SUBJECT: VOGTLE ELECTRIC GENERATING PLANT ESP SITE - ISSUANCE OF
AMENDMENT RE: REQUEST FOR CHANGES TO THE SITE SAFETY
ANALYSIS REPORT REGARDING ONSITE SOURCES OF BACKFILL

Amendment No. 2
Early Site Permit No. ESP-004

SAFETY EVALUATION BY THE OFFICE OF NEW REACTORS

RELATED TO AMENDMENT NO. 2 TO EARLY SITE PERMIT NO. ESP-004

Figure 1. NOI Index within the VEGP Exclusion Area Boundary

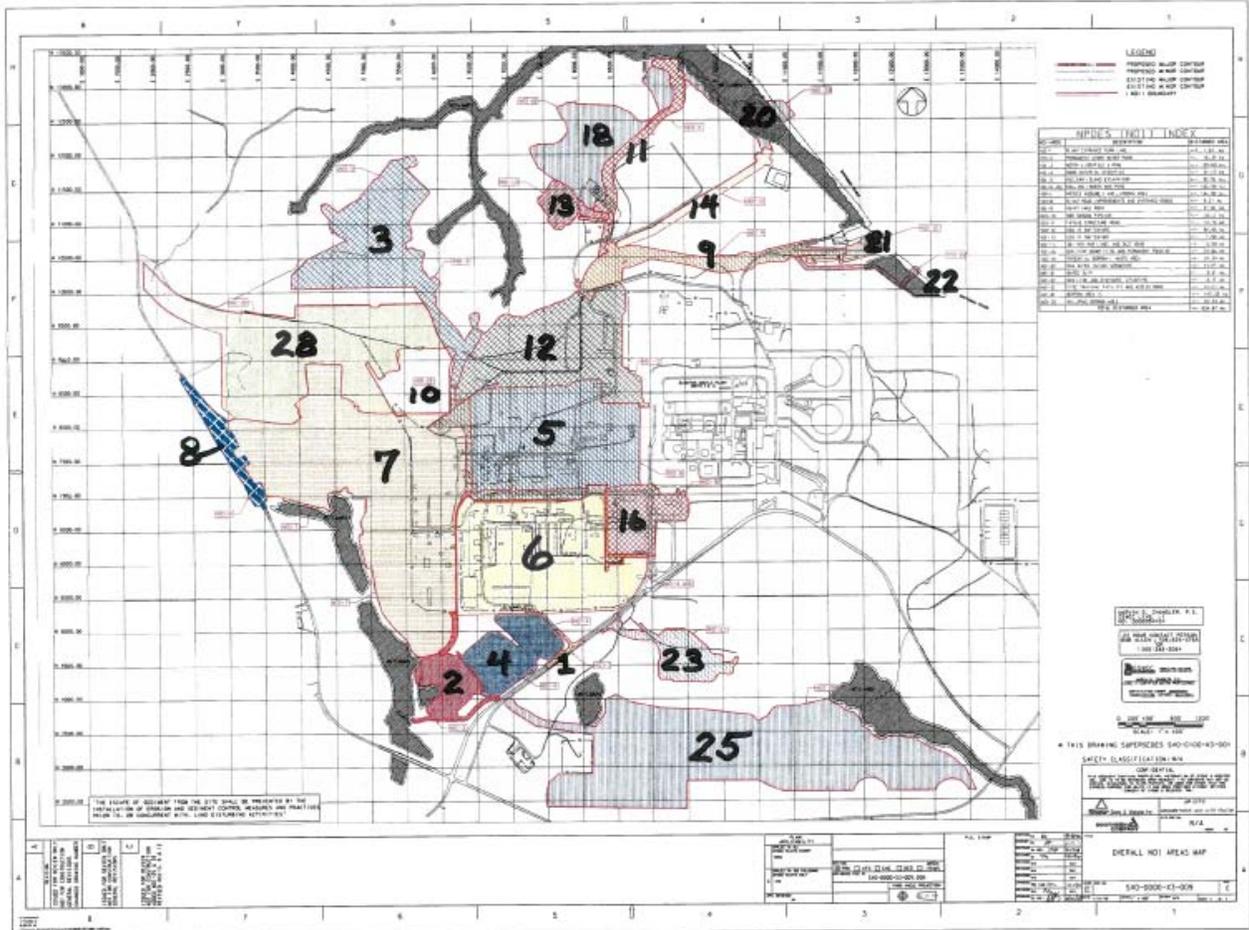
The additional borrow areas where the qualified Category 1 and 2 backfill soil may be obtained are within the VEGP Exclusion Area Boundary (EAB) as presented in Figure 1, "Map Showing Extent of Barnwell Group," in Attachment 2 to the applicant's letter dated April 28, 2010. The exact locations of the three additional borrow areas correspond to the Notice of Intent (NOI) number shown in SER Figure 1. The staff considered that the VEGP site is well studied and its geological features are well known based on information submitted by SNC in its amendment request, as well as from the information previously submitted to the NRC. This previously-submitted information includes site investigations performed for the licensing of the currently-operating units at the VEGP site (VEGP Units 1 and 2), for issuance of the VEGP ESP and LWA, and in support of the pending COL application for Units 3 and 4. The staff also considered information provided in the U.S. Geological Survey Professional Publication 1603 (USGS, 2001, Reference 13).

To demonstrate that the Barnwell Group extends across the VEGP site, SNC supplied two figures in Attachment 2 to its RAI Response letter dated April 28, 2010. Figure 1 ("Map Showing Extent of Barnwell Group") illustrates the extent of the Barnwell Group within the EAB and the surrounding area. Figure 2 ("Vogle Plant Area General Stratigraphic Column") provides a stratigraphic column containing descriptions of the geological characteristics of the Barnwell Group. In Attachment 3 of the letter, the applicant provided additional test pit and boring logs, which are not from the original three borrow areas identified in the SSAR, to support the conclusion that the Barnwell Group extends throughout the VEGP site.

1. Site investigation data, particularly the test pit and boring logs, confirm that the Barnwell Group extends in the Western portion of North Stockpile area, Borrow Area 1C, and Railroad Borrow Area within the EAB at the VEGP site.

3. The three additional areas proposed in the LAR request, where the Barnwell Group is clearly defined within the VEGP EAB, can be used as potential borrow sources for Category 1 and 2 backfill material from the Upper Sand Stratum.
